SR 3/US 41/COBB PARKWAY WIDENING FROM PACES MILL ROAD TO AKERS MILL ROAD

STP00-0001-05(047), P.I. No. 721152

Value Engineering Study Report

March 2011

Alternative Shoulder
w/ 10' Multi Use Trail

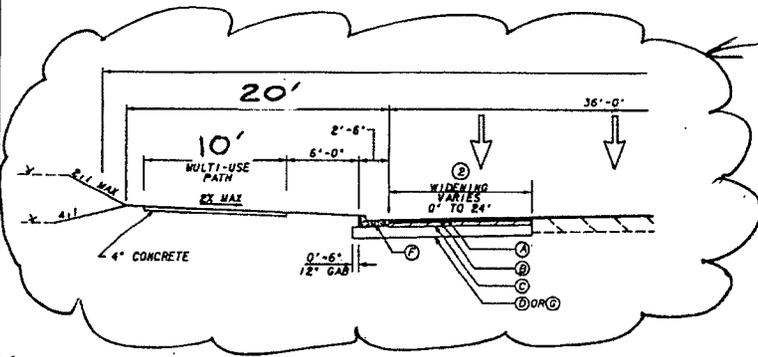
Provide a 10-ft.-wide multi-use trail along the length of the project on the west side of SR 3/US 41.

AASHTO recommends a minimum of 10 feet width for multi-use trails and it may be necessary to provide this width to save commercial parking spaces in the following areas:

Original Design – 22'-0" shoulder with 6'-0" grass strip

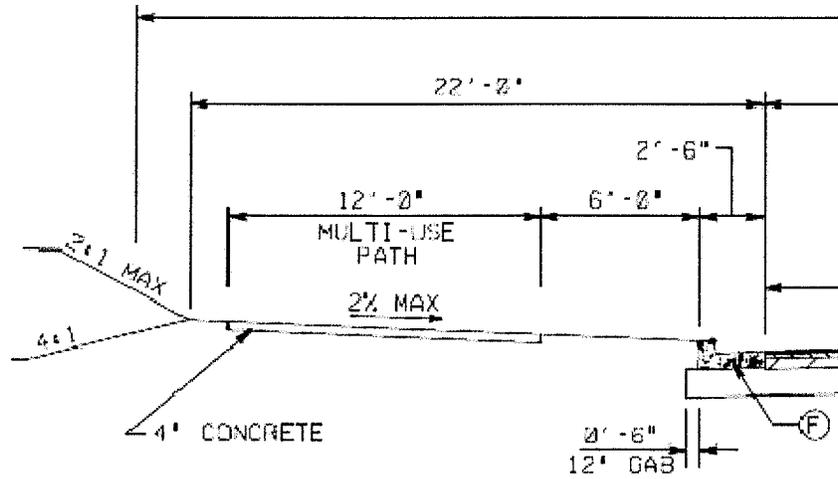
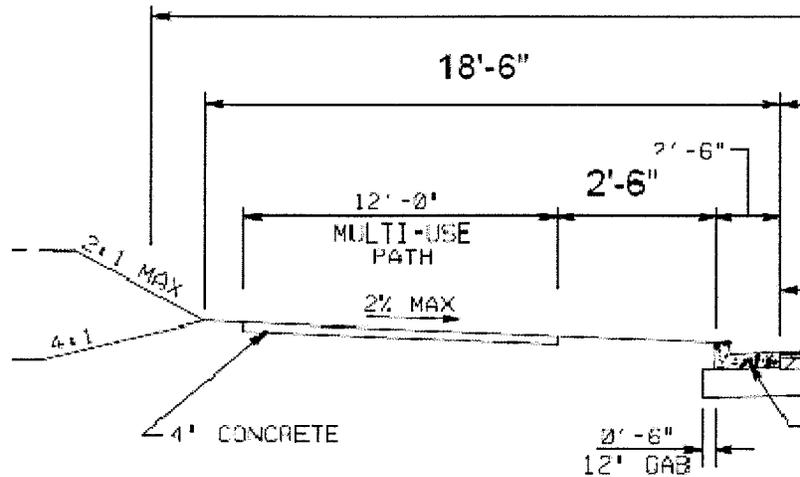
**DESCRIPTION: PROVIDE A 2-1/2-FT.-WIDE STAMPED CONCRETE STRIP
IN LIEU OF A 6-FT.-WIDE GRASS STRIP ON THE LEFT
SHOULDER THE LENGTH OF THE PROJECT**

A 2-1/2 -ft.-wide stamped concrete strip adjacent to a 12-ft.-wide multi-use trail is adequate to meet the ADA requirement for crossing curb-cut type driveways since 8 ft. of the 12 ft. trail will be outside of the curb-cut valley gutter. It is important to note that at this time there does not appear to be any "dust-pan" or curb-cut type driveways that infringe on the ADA requirement of a 2 % cross-slope on the construction plans. The removal of the 6-ft.-wide grass strip will eliminate the need for maintenance mowing of grass. It will also reduce the earthwork requirement since the shoulder will be 3-1/2 ft. narrower. It is important to point out that this narrower shoulder will not affect the clear zone requirements since the plans already include guardrail along the 2:1 slopes, and everywhere else the roadway is either in a cut section or there are right turn lanes providing an additional 12 ft. of clear-zone. The stamped concrete provides 2-1/2 ft. additional paved surface width for pedestrians and maintenance vehicles along the trail.

Alternative Design – 18'-6" shoulder with 2'-6" stamped concrete

Original Design – 16'-0" shoulder with 6'-0" grass strip

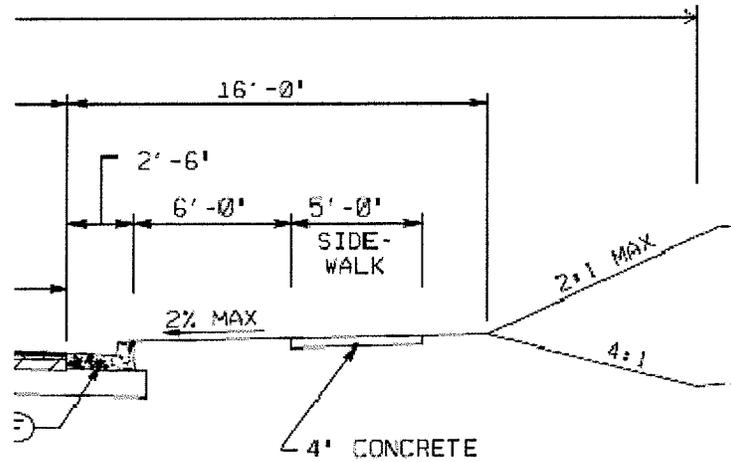
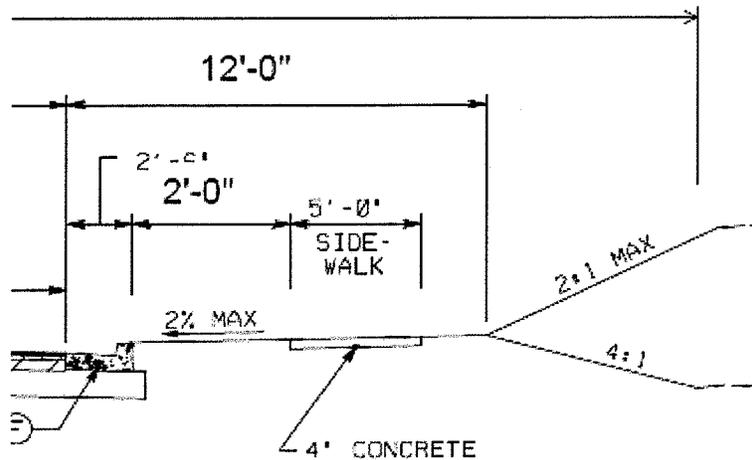
**DESCRIPTION: PROVIDE 2-FT.-WIDE STAMPED CONCRETE IN LIEU OF
6-FT.-WIDE GRASS STRIP ON THE RIGHT SHOULDER
FOR THE ENTIRE LENGTH OF PROJECT**

A 2 ft. grass strip adjacent to a 5-ft.-wide sidewalk is adequate to meet the ADA requirement for crossing “street-type” driveways since the driveway radii are with curb and gutter and not a curb cut with valley gutter. It is important to note that at this time there does not appear to be any “dust-pan” or curb-cut type driveways that infringe on the ADA requirement of a 2 % cross-slope in the construction plans. The removal of the 6 ft. grass strip will eliminate the need for maintenance mowing of grass. It will also reduce the earthwork requirement since the shoulder will be 4 ft. narrower. It is important to point out that this narrower shoulder will not affect the clear zone requirements since the plans already include guardrail along the 2:1 slopes, and everywhere else the roadway is either in a cut section or there are right turn lanes providing an additional 12 ft. of clear-zone. The stamped concrete will provide 2 ft. additional width of pavement for pedestrians along the sidewalk.

Alternative Design – 12'-0" shoulder with 2'-0" stamped concrete

Alt. No. R-6
Sheet 2 of 5

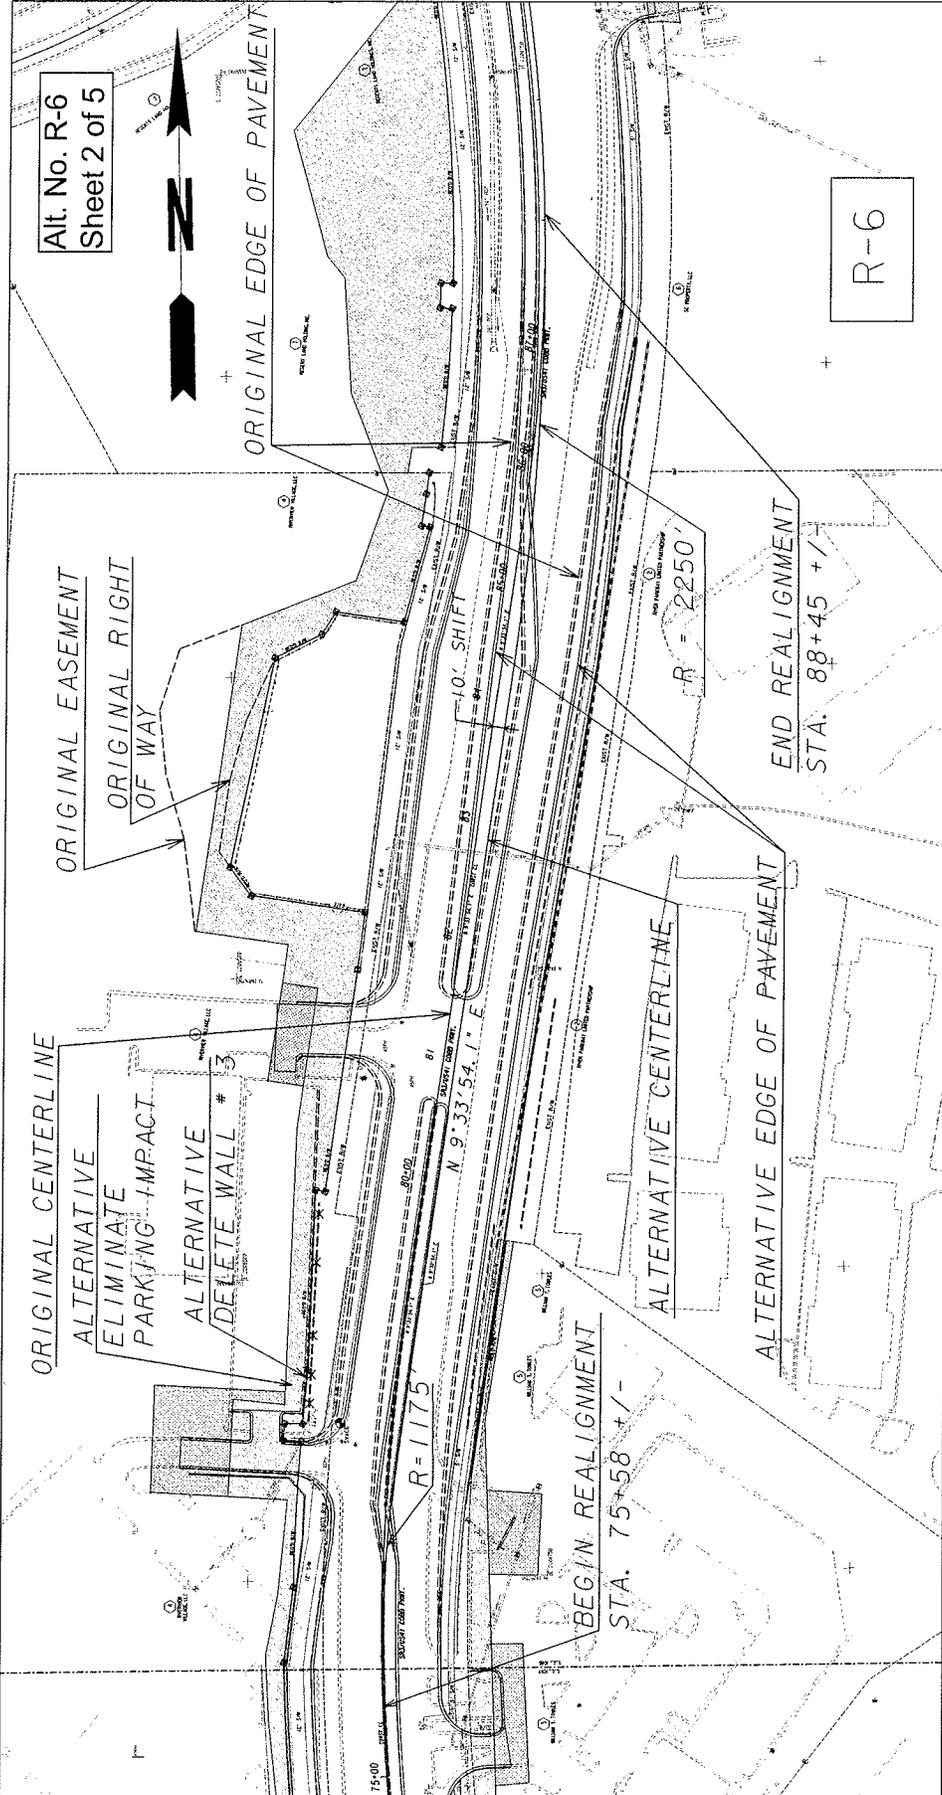
PROJECT: SR 3/US 41/COBB PKWY. WIDENING FROM PACES MILL RD. TO AKERS MILL RD. <i>Cobb County, Georgia</i>	ALTERNATIVE NO.: R-6
DESCRIPTION: SAVE 22 COMMERCIAL PARKING SPACES NEAR STA. 78+50 LT BY SHIFTING THE ALIGNMENT FROM STA. 75+58 +/- TO STA. 88+45 +/- FURTHER TO THE RIGHT AND ELIMINATING WALL NO. 3 (STA. 77+89 LT TO STA. 79+65 LT)	SHEET NO.: 1 of 5

This alternate involves shifting the SR 3/US 41/Cobb Parkway alignment to save parking spaces on Parcel 4. A narrower, 2½-ft.-wide stamped concrete strip will also be required instead of a 6-ft.-wide grass strips from Sta. 75+58 LT to Sta. 88 +45 LT to further minimize the parking impacts. In the process, Wall No. 3 is eliminated and the required right-of-way and required easement for the proposed detention pond is also reduced.

ALTERNATIVE
DELETE WALL # 3

Alt. No. R-7
Sheet 2 of 4

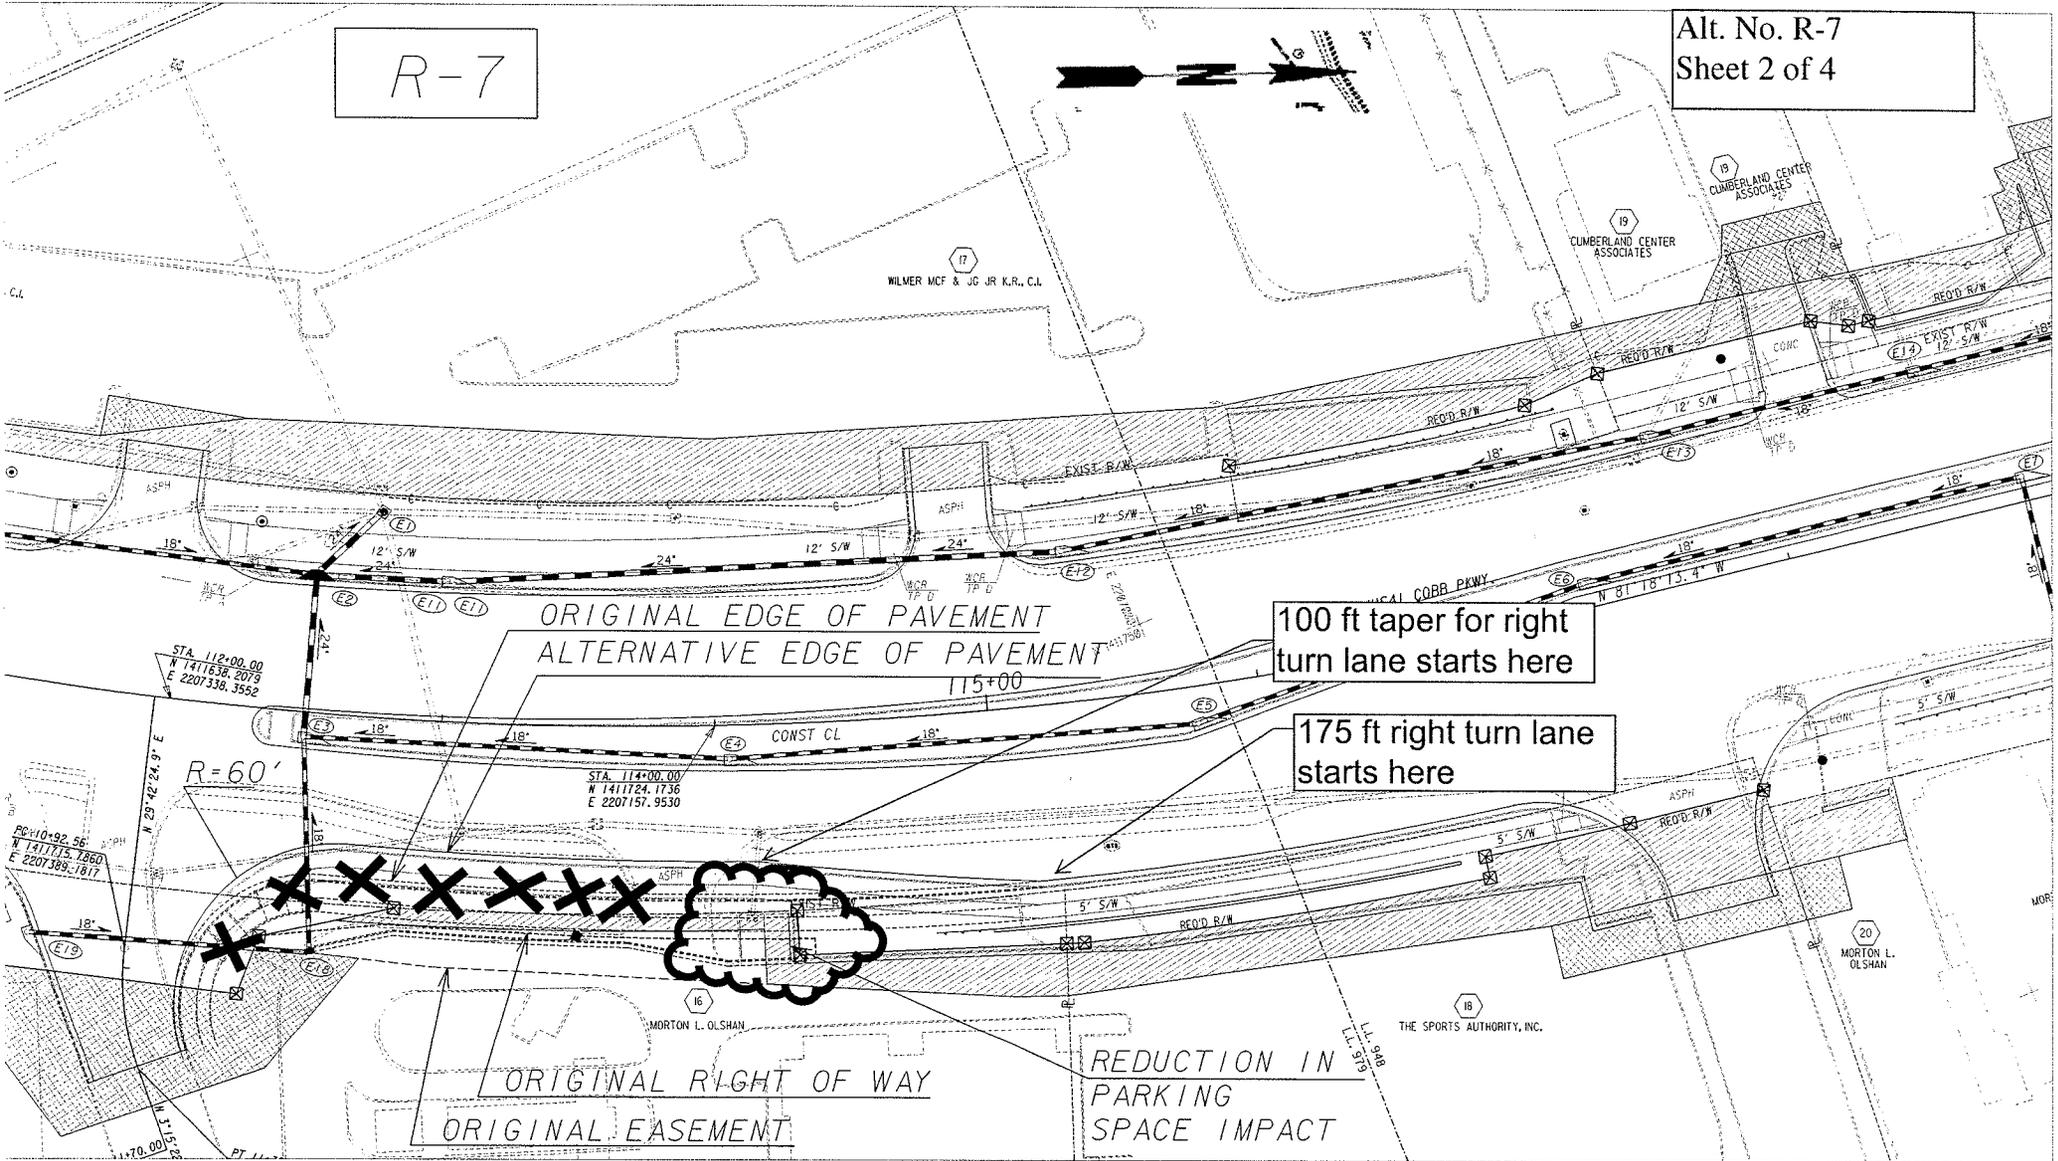
PROJECT: SR 3/US 41/COBB PKWY WIDENING FROM PACES MILL RD. TO AKERS MILL RD <i>Cobb County, Georgia</i>	ALTERNATIVE NO.: R-7
DESCRIPTION: PROVIDE A 175 FT. RIGHT TURN LANE TO THE ACCESS DRIVE AT STA. 117+46 RT	SHEET NO.: 1 of 4

Provide a 175-ft.-long right turn lane with 100 ft. taper for the access drive at Sta. 117+46 RT.

100 ft taper for right turn lane starts here

Alt. No. R-13
Sheet 2 of 4

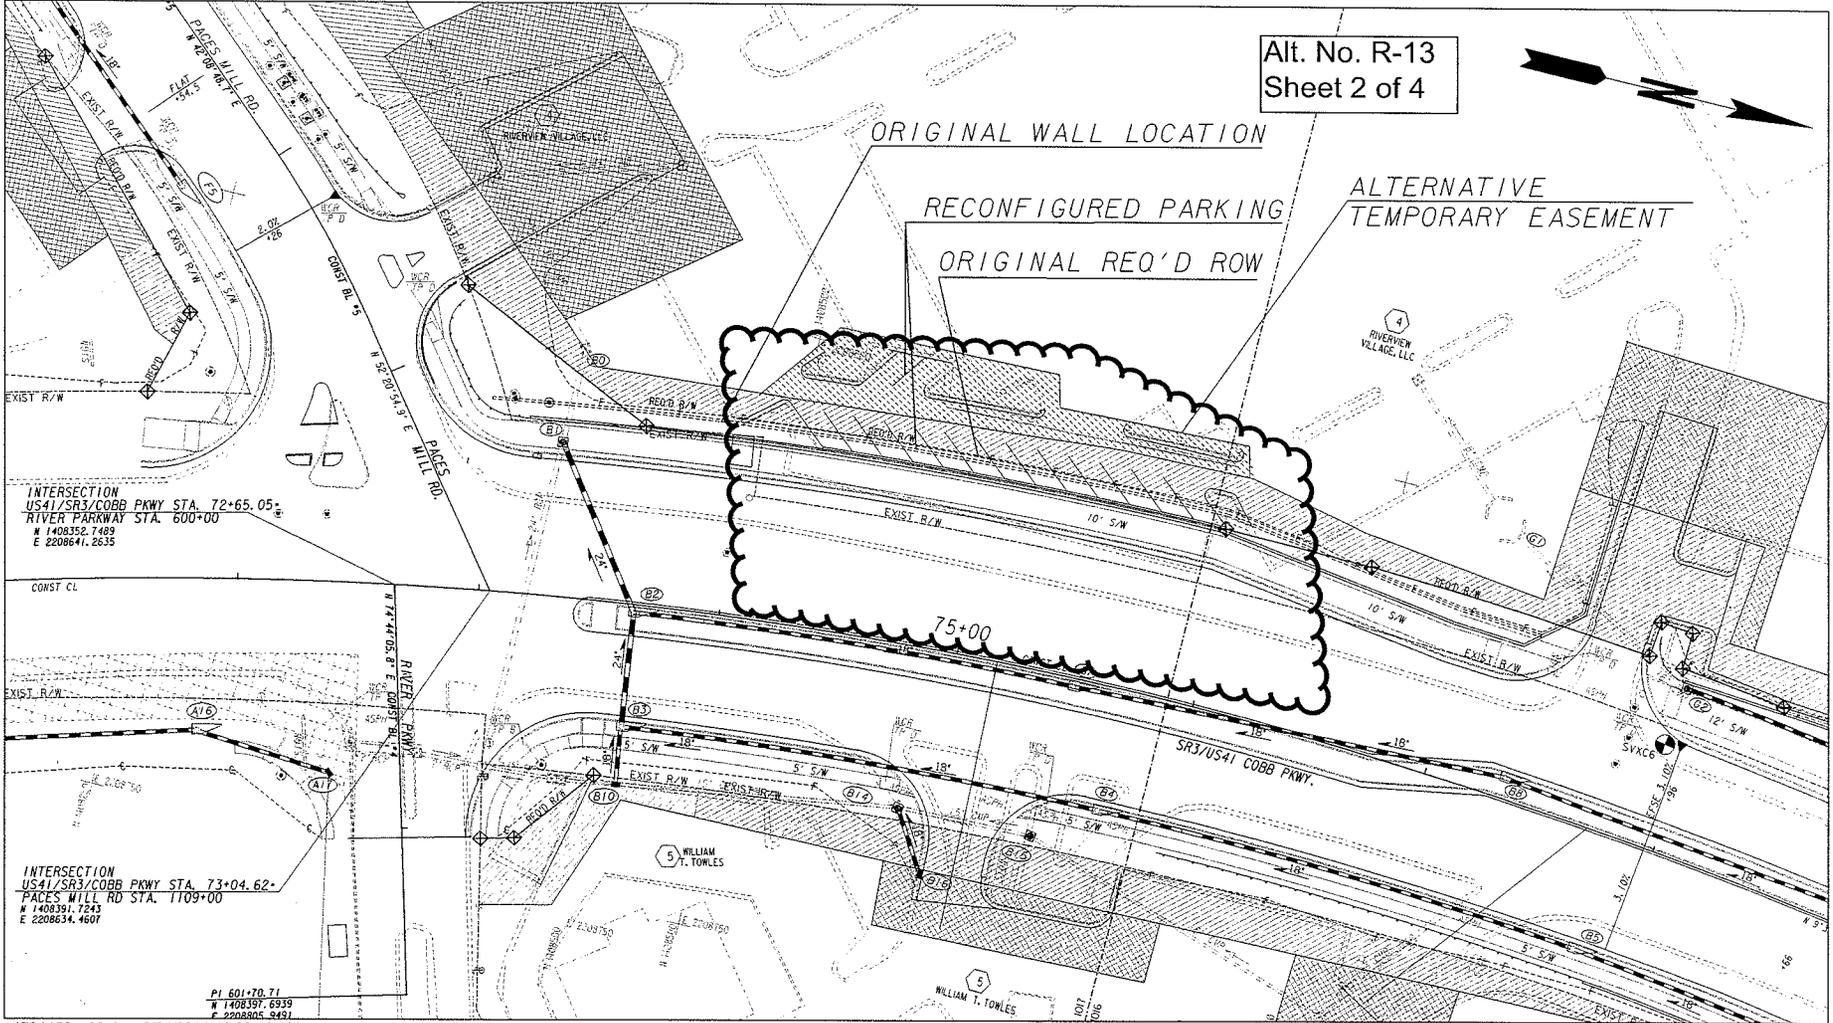
PROJECT: SR 3/US 41/COBB PKWY WIDENING FROM PACES MILL RD. TO AKERS MILL RD <i>Cobb County, Georgia</i>	ALTERNATIVE NO.: R-13
DESCRIPTION: SAVE ELEVEN COMMERCIAL PARKING SPACES NEAR STA. 74+50 LT BY REDUCING THE WIDTHS OF THE RIGHT TURN LANE, THE MULTI-USE TRAIL, AND THE GRASS STRIP BETWEEN STA. 73+16 LT AND STA. 75+94 LT	SHEET NO.: 1 of 4

Provide an 11-ft.-wide right turn lane, 2-1/2-ft.-wide stamped concrete, and 10-ft.-wide multi-use trail between Sta. 73+16 LT and Sta. 75+94 LT. Shift the proposed MSE wall closer to the roadway. With this shift, parking spaces angled at 45 degrees and retain 11 parking spaces.

Reducing the right turn lane width as well as reducing the width of the urban shoulder will save 11 parking spaces in the adjacent commercial parking lot. Since the through lanes are already 11 ft. lanes, the alternative right turn lanes will match the through lanes.

Alt. No. R-14
Sheet 2 of 4

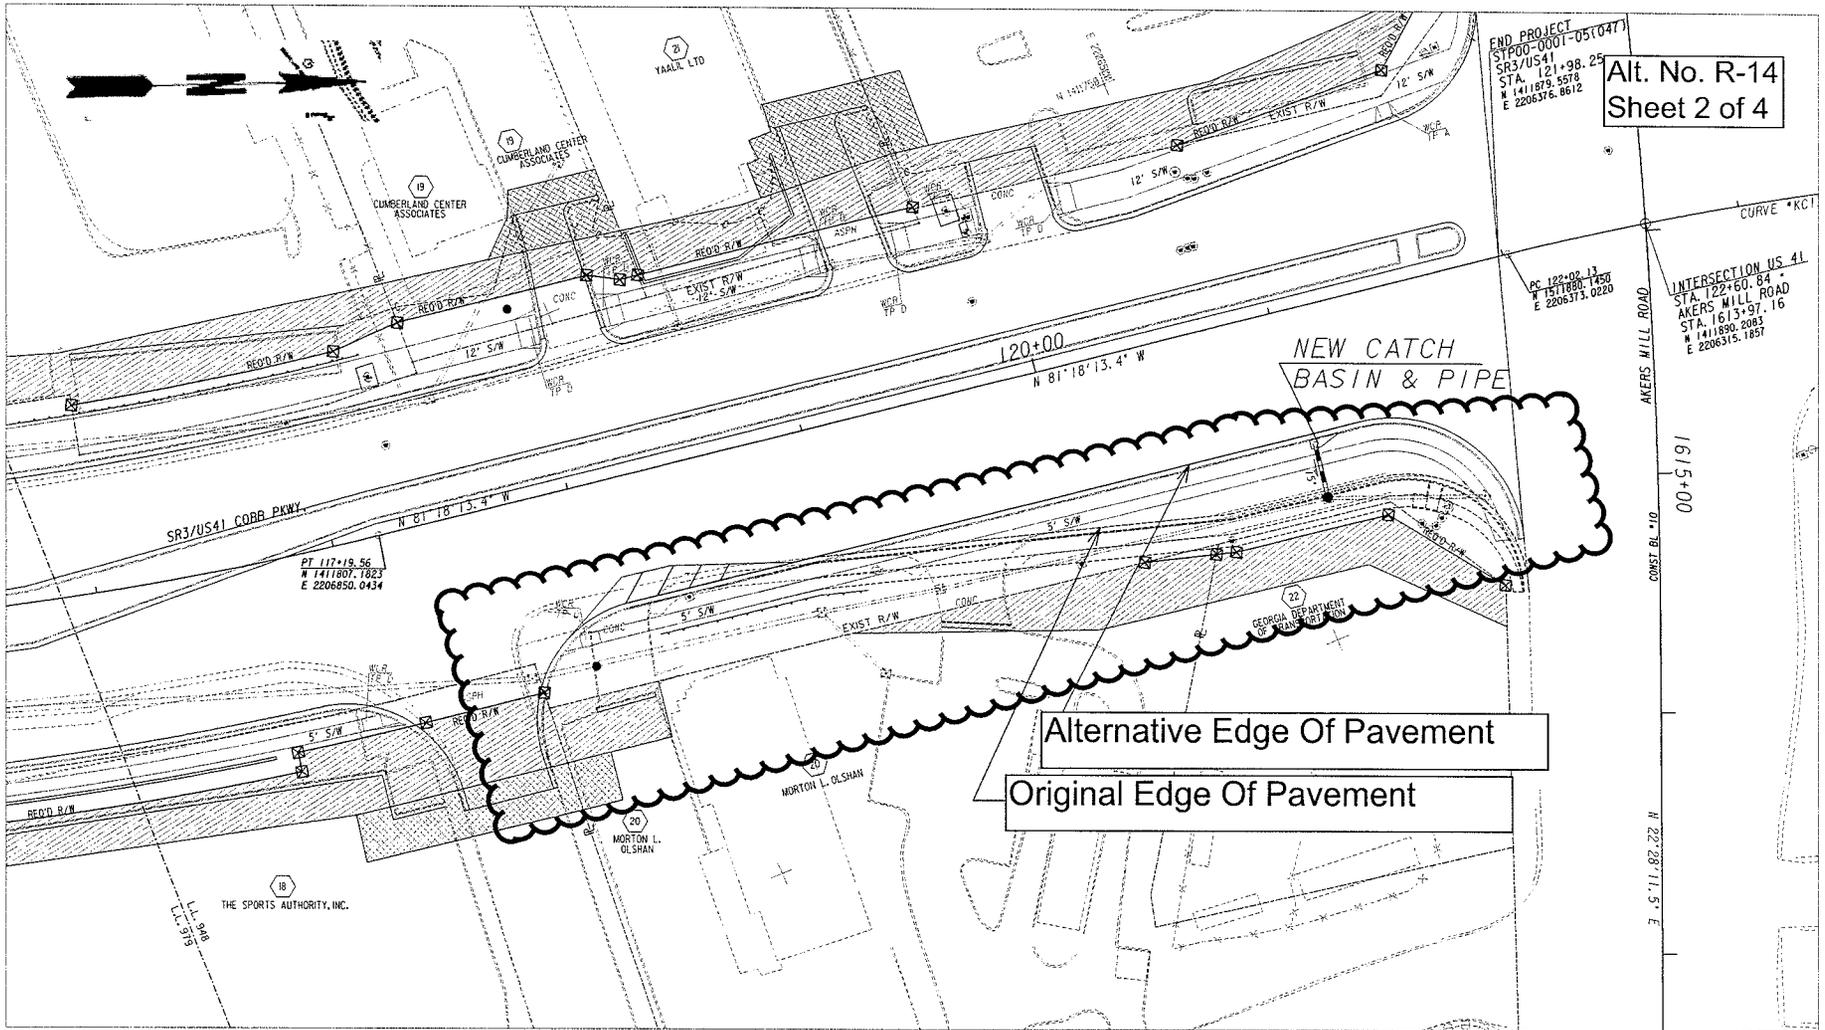
The current design uses a short existing right turn lane which is only 70-ft.-long with a 189-ft.-long taper for 290 vehicles per hour turning right. Since SR 3/US 41 has four other lanes approaching this intersection, converting the fourth lane to the right turn only lane would provide for much more capacity for right turns. This would also allow for a free right turn from Akers Mill Road onto SR 3/US 41 into the fourth lane on the opposite side of the intersection. It is important to note that the current right turn lane is so short that the queue through traffic prevents turning vehicles from accessing the right turn lane. The alternative design would eliminate the required right-of-way and easement along the right turn lane.

Alternative Edge Of Pavement
Original Edge Of Pavement
